ST. TAMMANY PARISH

Addendum No.: 1

Bid#: 22-4-2

Project Name: Third Avenue Bridge Replacement at Ponchitolawa Creek

SHEET NUMBER	3
CITY	COVINGTON
PARISH	ST. TAMMANY
RESIGNED	JHS
CHECKED	DAC
DETAILED	JAC
CHECKED	DAC
SERIES NUMBER	
BY	JHS
DATE	2/25/2022
NO.	1
REVISION OR CHANGE ORDER DESCRIPTION	
SUMMARY OF ESTIMATED QUANTITIES THIRD AVE. BRIDGE

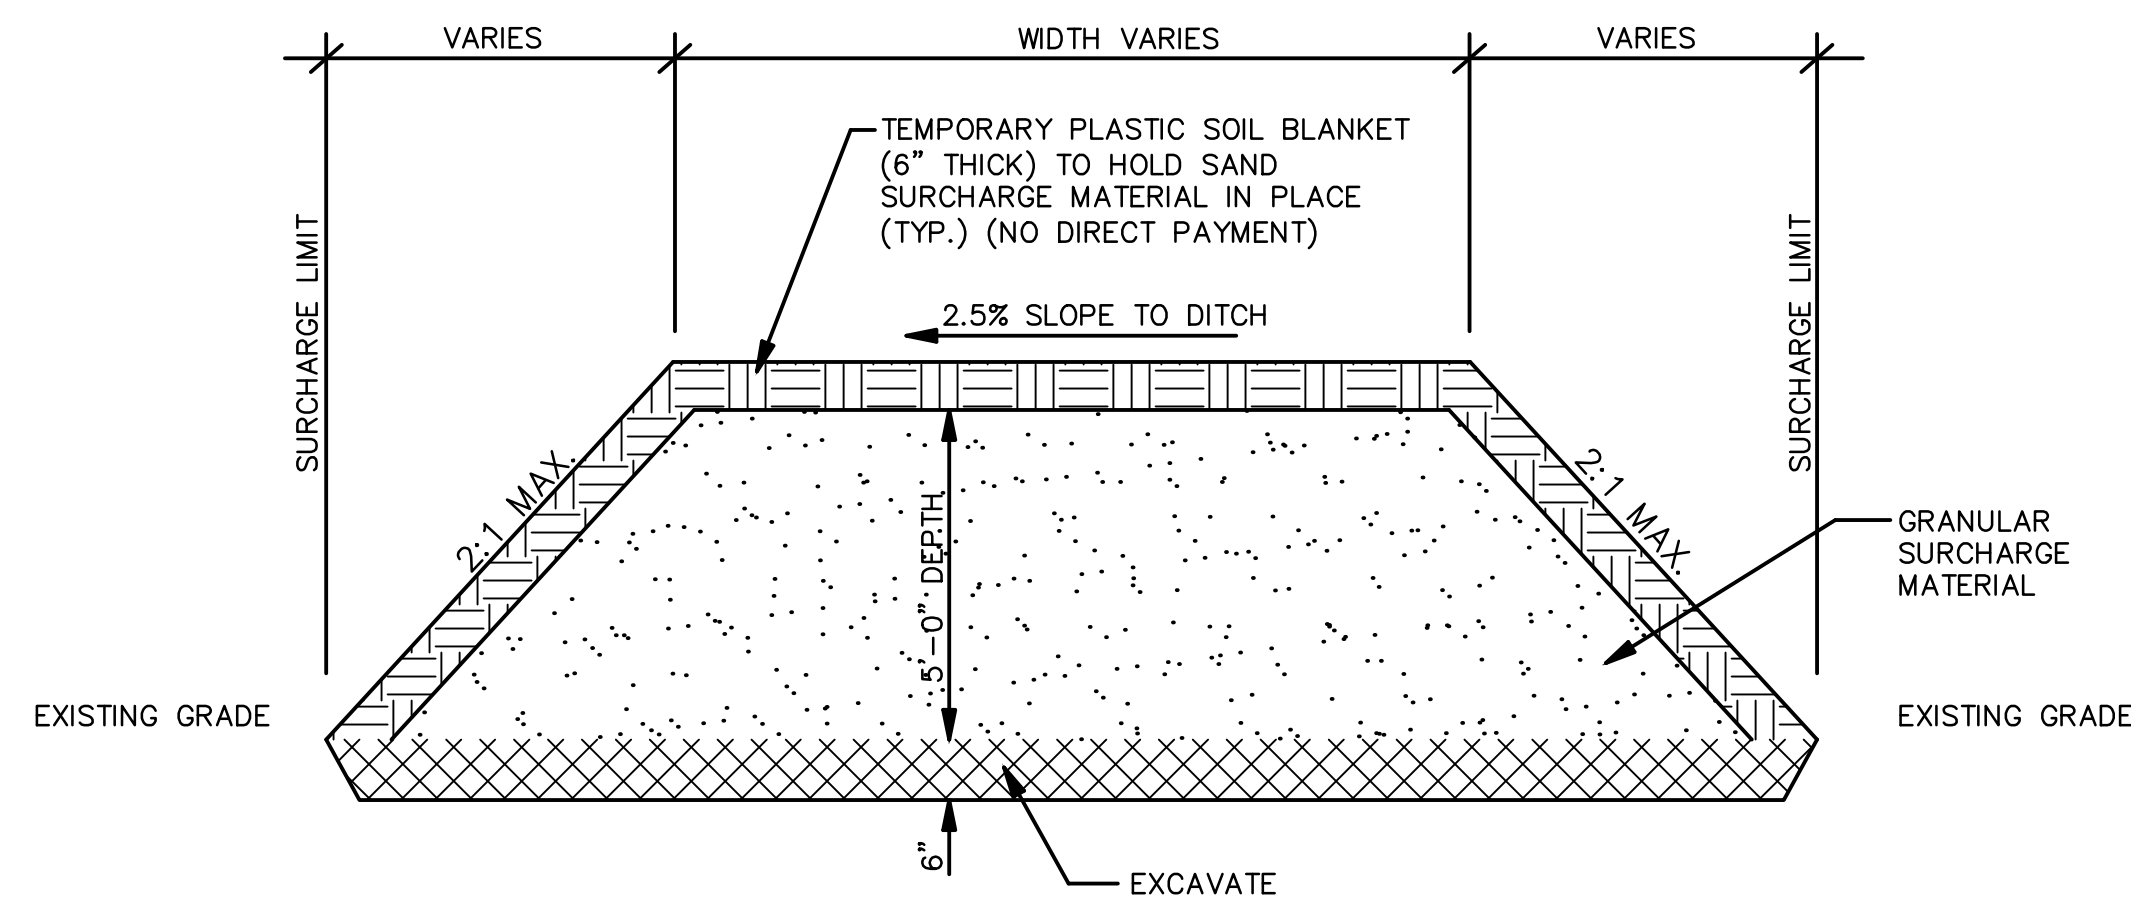
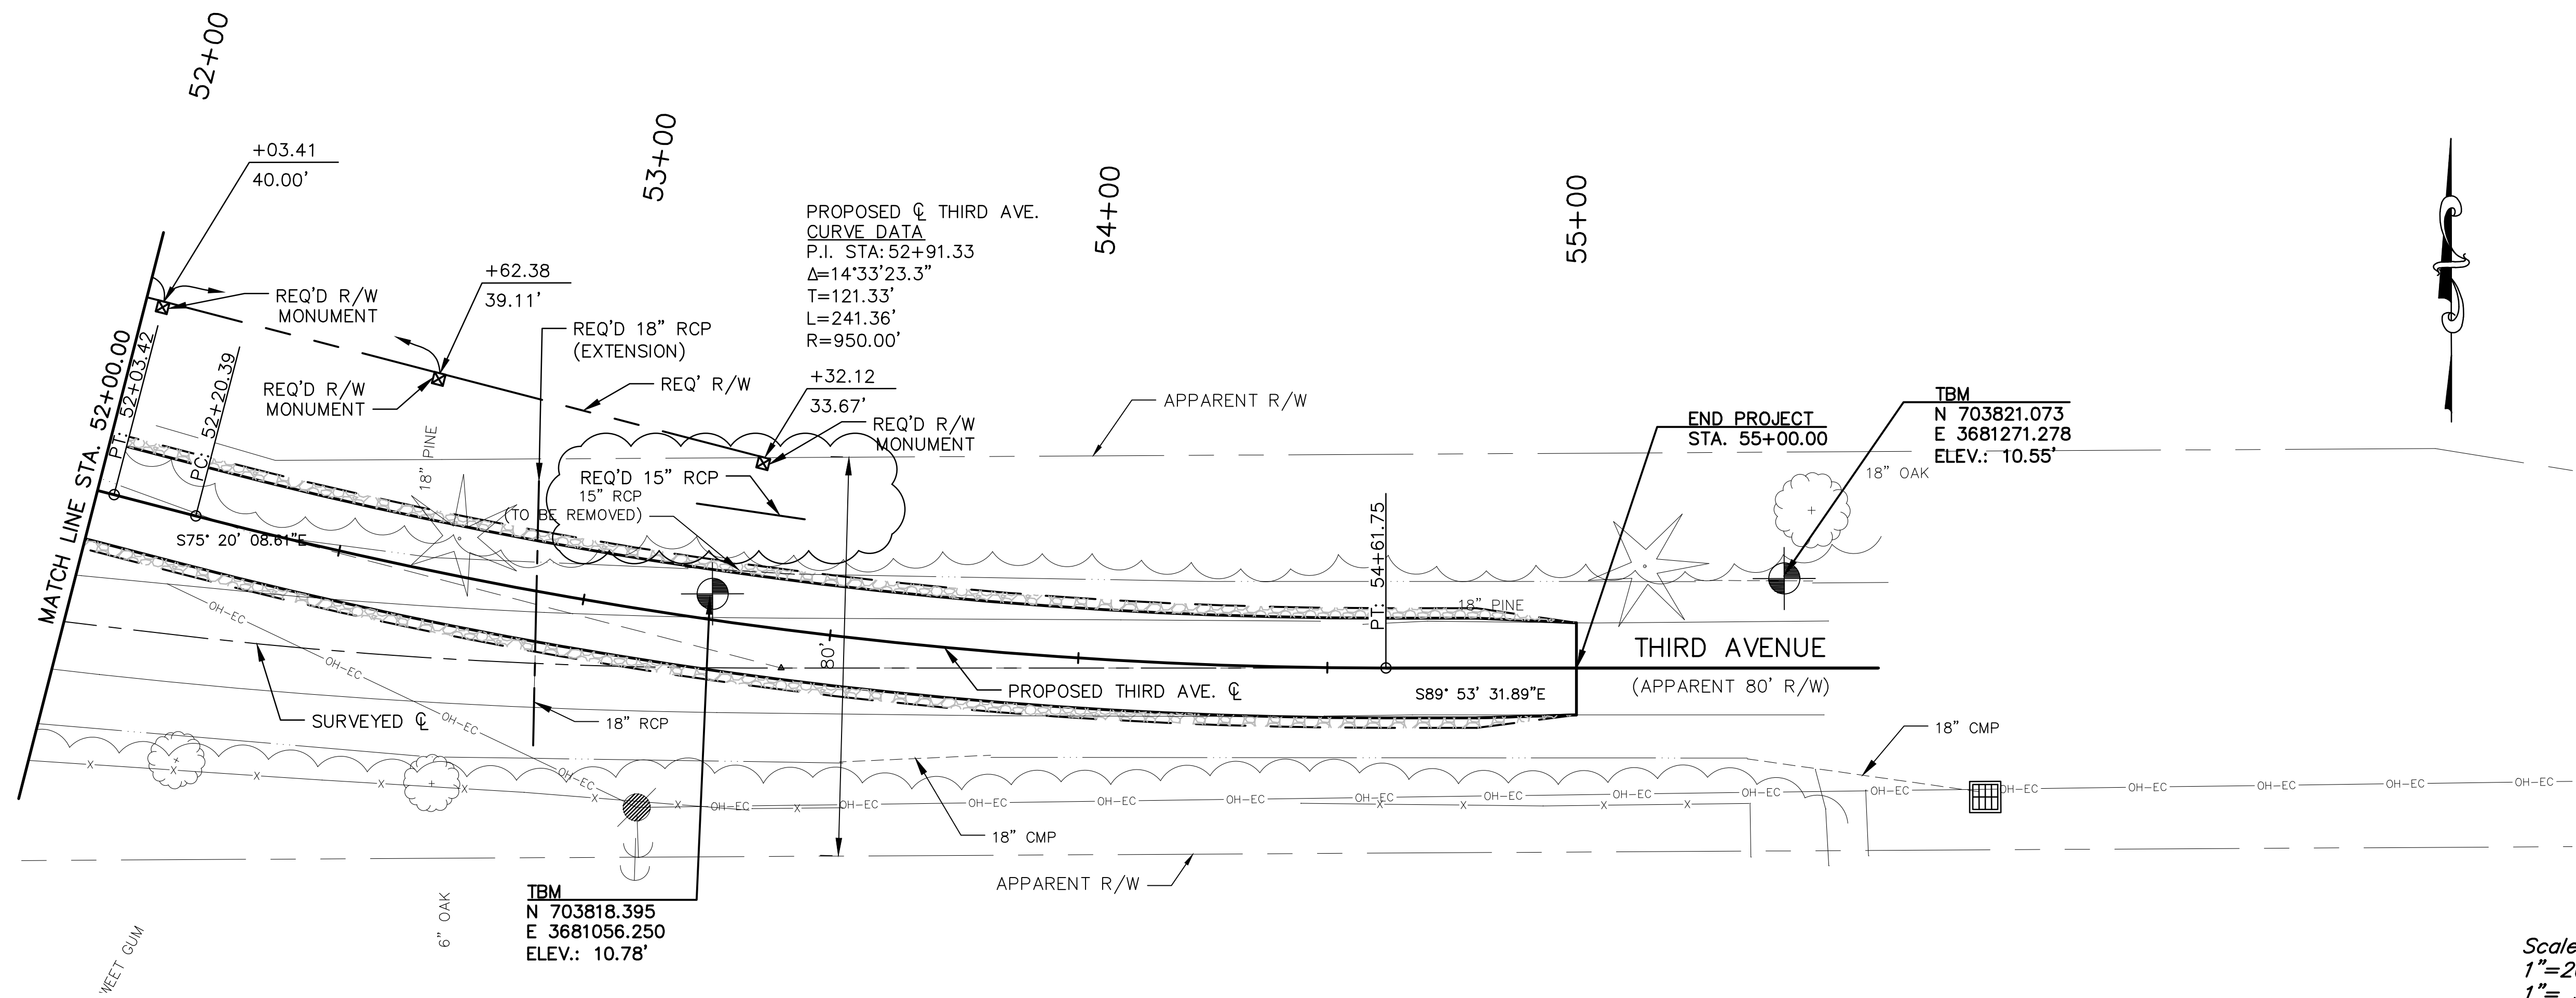
Question 3: Ref. Dwg. Sheet 3, Note 8 – Where is Wrights Creek or should it read Ponchitolawa Creek?

Question 5: Ref. Bid Item 804-01-00200 and Pile Data Table on Dwg. Sheet 103 – Shouldn’t the bid quantity be 2,520 not 2,760?

Answer 3: Ponchitolawa Creek is the correct name. This correction has been made in the attachment “Sheet 3 - Summary of Estimated Quantities – Revised.pdf.”

Answer 5: The Bid Item 804-01-00200 bid quantity is 2,520 LF. This correction has been made in the attachments “Sheet 3 - Summary of Estimated Quantities Revised.pdf” and “Unit Price Form – Page 6 of 7 – Revised.pdf.”

PLAN AND PROFILE SHEETS

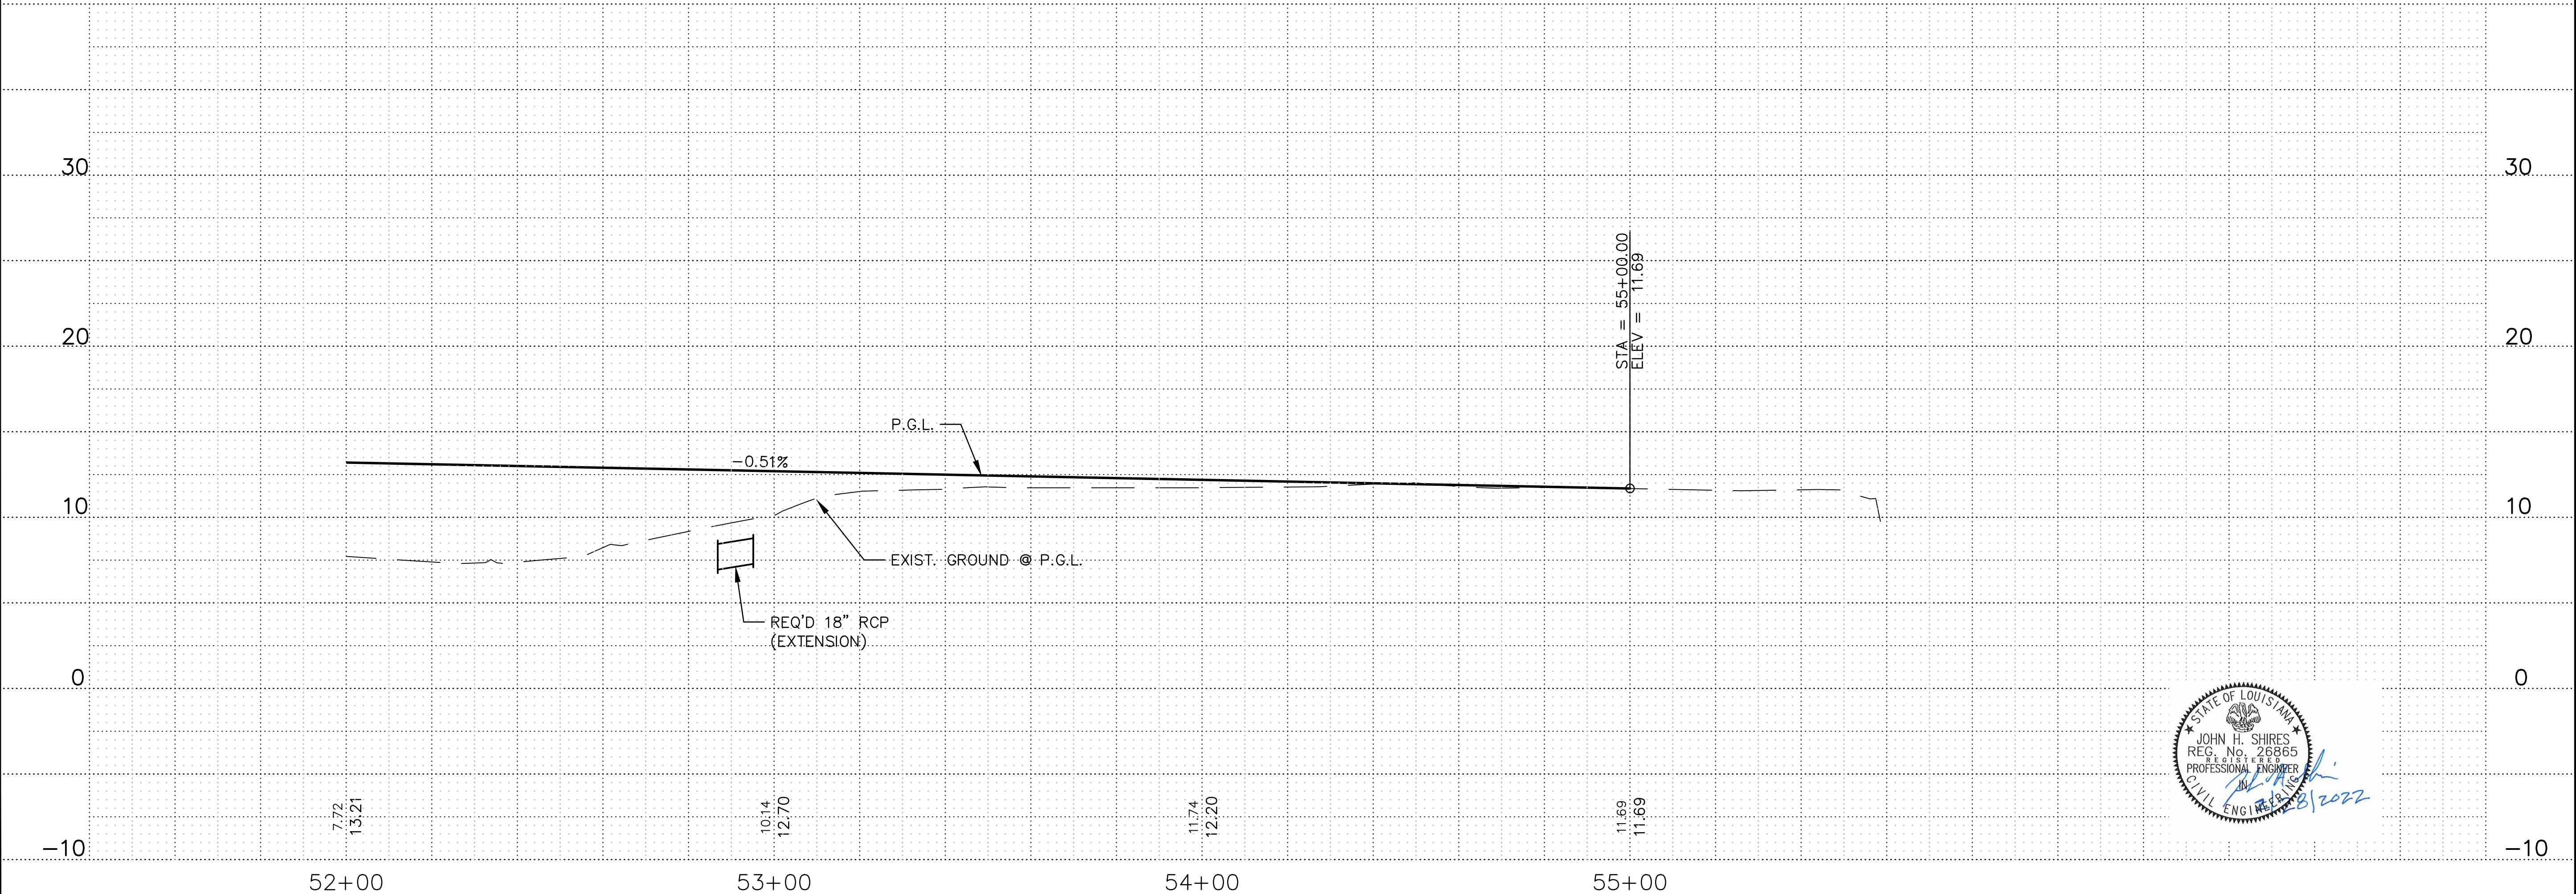
Question 6: Ref. Bid Item 701-05-01020, 15” Side Drain – Can you provide a location for this item?

Answer 6: The 15” side drain item is to replace the 15” RCP to be removed. The existing is approx. 220’ east of the existing intersection of Janice and 3rd Ave. on the North Side of the street. This has been clarified in the attachment “Sheet 7 - Plan and Profile Sheets – Revised.pdf.”
